*Commissioner for Patents
Response to March 31, 2004 Office Action
Filed July 30, 2004 via facsimile transmission
Page 7 of 13*

*Serial: 09/779358
Art Unit: 2154
Examiner: Patel
Docket AUS9 2000 0516 US1*

Amendments to the Drawings:

FIG. 5

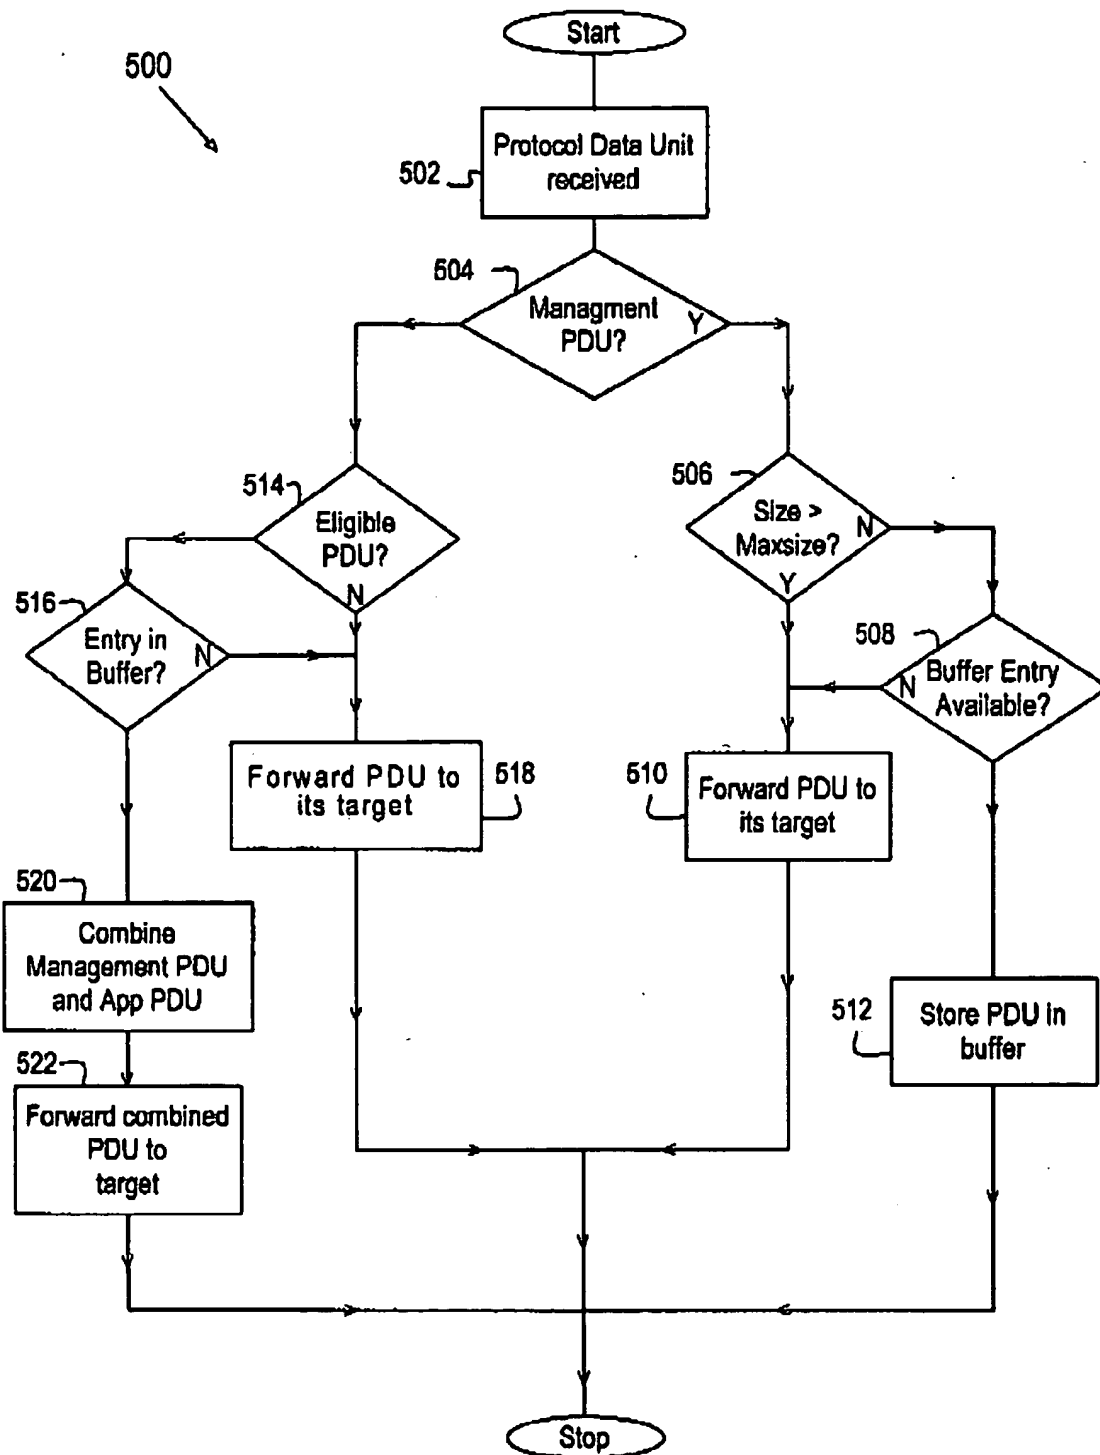
The attached sheet of drawings includes changes to FIG. 5. This sheet, which includes FIG. 5 only, replaces the original sheet 4 (of 7) which also included FIG. 5 only. As shown on the attached Annotated Sheet Showing Changes, the word "Protoco" has been replaced with the word "Protocol" in block 502 of the flow diagram. No other changes have been made.
